## NORTH HERTFORDSHIRE DISTRICT COUNCIL

### PLANNING CONTROL COMMITTEE

8.            **18/03348/FP VINE COTTAGE, MAYDENCROFT LANE, GOSMORE, HITCHIN, HERTS, SG4 7QB (Pages 3 - 8)**

# North Hertfordshire District Council Building Conservation comments

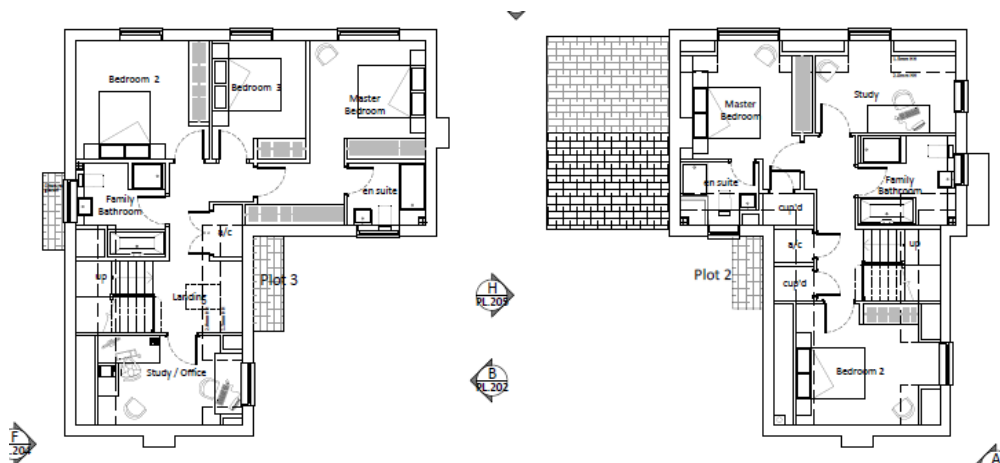
I previously commented on 10/05/2016 and I now respond following receipt of amended plans on 12<sup>th</sup> June 2019. The description clearly needs to be changed to perhaps:

Although it is quite apparent from the size of units and internal layout (see below) that Plot 1 could easily be converted into a 5 bed (extensive first floor providing only two bedrooms) whilst Plots 2 & 3 could easily become 4 beds if the study rooms become bedrooms.

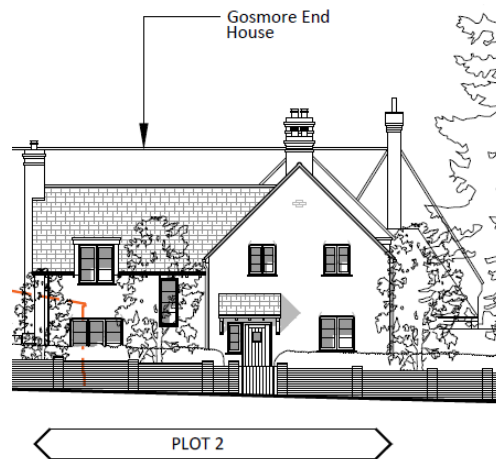
I do not intend covering the same matters raised previously but I reiterate that whilst the development of the application site will erode the spacious quality, if handled carefully, could still make a positive contribution to the special character of the area. I previously stated that there is an opportunity for at least presenting one of the new properties with a front aspect onto the Village Green.

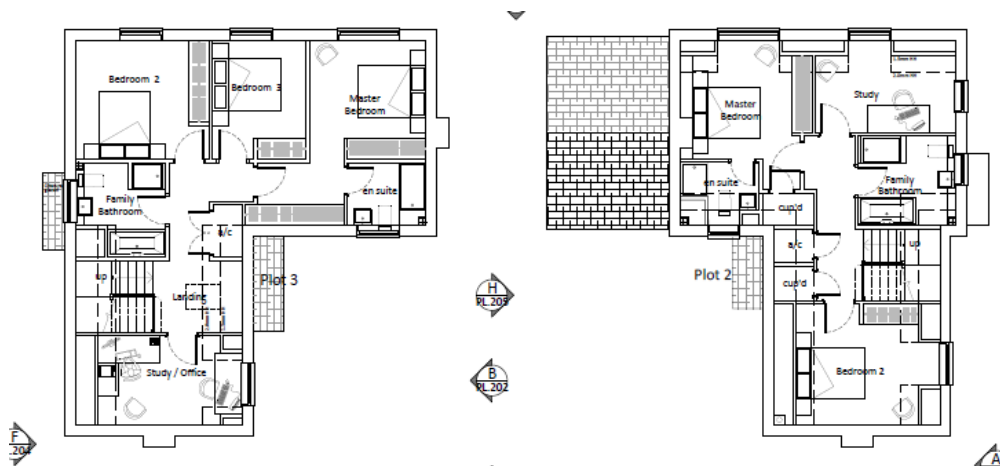
I previously commented on 10/05/2016 and I now respond following receipt of amended plans on 12<sup>th</sup> June 2019. The description clearly needs to be changed to perhaps:

Although it is quite apparent from the size of units and internal layout (see below) that Plot 1 could easily be converted into a 5 bed (extensive first floor providing only two bedrooms) whilst Plots 2 & 3 could easily become 4 beds if the study rooms become bedrooms.

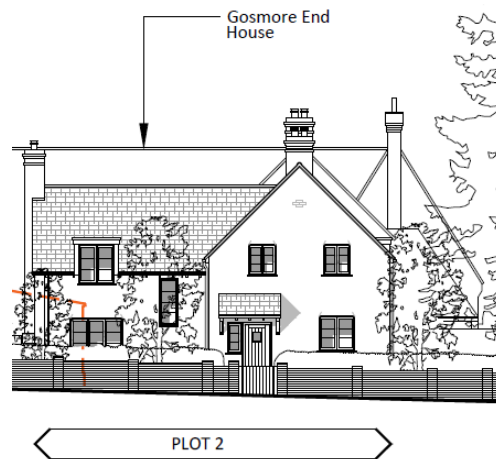
I do not intend covering the same matters raised previously but I reiterate that whilst the development of the application site will erode the spacious quality, if handled carefully, could still make a positive contribution to the special character of the area. I previously stated that there is an opportunity for at least presenting one of the new properties with a front aspect onto the Village Green.
